MECHANICAL DESIGN CONSIDERATION

Additional Requirements:

The Jordanian Civil Defence (JCD) has requested additional modifications on the diesel tank area, as follows:

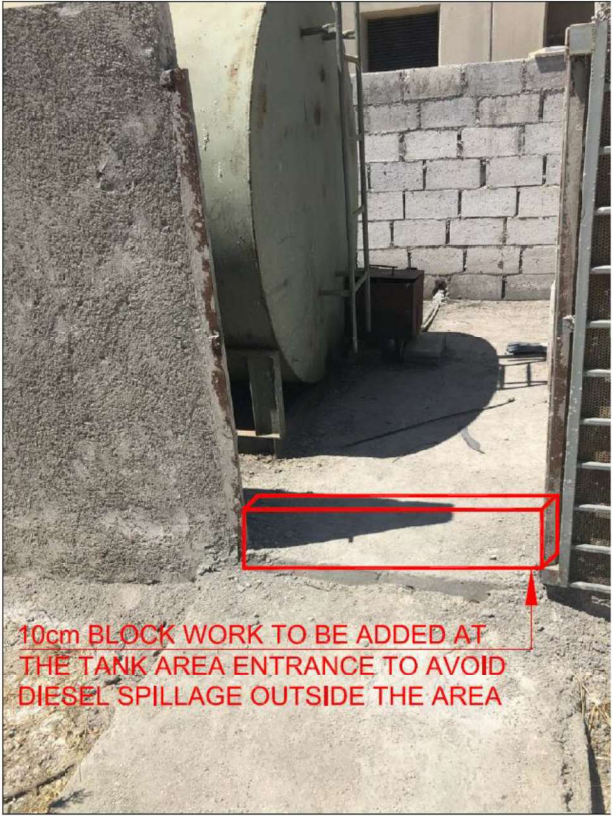
- 1- Adding a 10cm blockwork at the entrance of the diesel tank area, to avoid any diesel leakage to escape the area to the outside, as illustrated below
